Access Compliance Report

Public Rights-of-Way

(Curb Ramps)

Intersection ID: 4866	Main Street: E_MALLARD_CREEK_CHURCH_RD	Cross Street: N_TRYON_ST	Location: S
ADA ID: D32F94F00B3F	Ramp Type: Perp	Initial Pass/Fail: Fail	Overall Compliance: No
Severity Score: 22.5			
Codes/Mitigation Info/Possible Solution		Field Measurements/Component Compliance

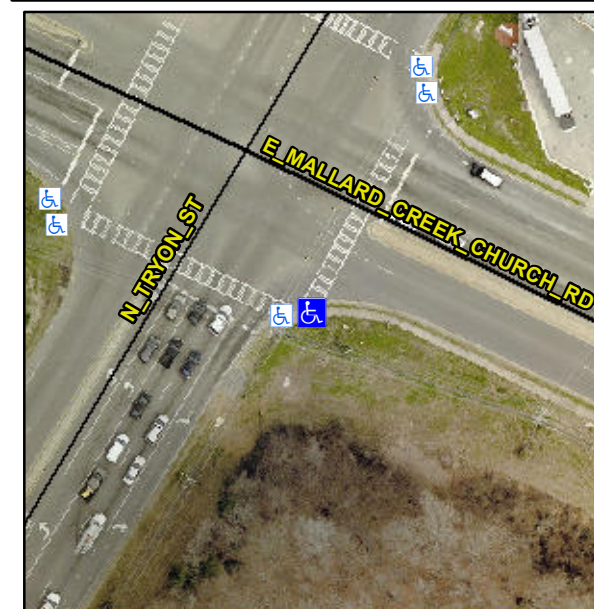
R304.5.1, R304.2.2, R304.5.3

Compliance	Description	Data	Compliance	Description	Data
N/A	Ramp Length (in)	59.0	No	Ramp Slope (%)	8.6
No	Ramp Width (in)	42.0	No	Ramp XSlope (%)	4.9
N/A	Flare Type LT	N/A	N/A	Flare Type RT	N/A
N/A	Flare Slope LT (%)	N/A	N/A	Flare Slope RT (%)	N/A
N/A	Flare Traversable LT?	N/A	N/A	Flare Traversable RT?	N/A
N/A	Landing Length (in)	N/A	N/A	DWS Provided?	N/A
N/A	Landing Width (in)	N/A	N/A	DWS Contrast?	N/A
N/A	Landing Slope (%)	N/A	N/A	DWS Length (in)	N/A
N/A	Landing X Slope (%)	N/A	N/A	DWS Full Width?	N/A
N/A	Landing Curb? (Y/N)	N/A	N/A	DWS Offset (in)	N/A
N/A	Shared Landing?	N/A			
N/A	Gutter Ponding?	N/A	N/A	Gutter Slope (%)	N/A
N/A	Gutter Lip Ht (in)	N/A	N/A	Gutter X Slope (%)	N/A
N/A	Painted X Walk1?	Yes	N/A	Painted X Walk2?	N/A
	X Walk 1 Direction	To NE		X Walk 2 Direction	N/A
N/A	X Walk 1 Width (in)	97.0	N/A	X Walk 2 Width (in)	N/A
	X Walk 1 Slope (%)	0.4		X Walk 2 Slope (%)	N/A
	X Walk 1 X Slope (%)	3.7		X Walk 2 X Slope (%)	N/A

Remove & Replace Entire Ramp.
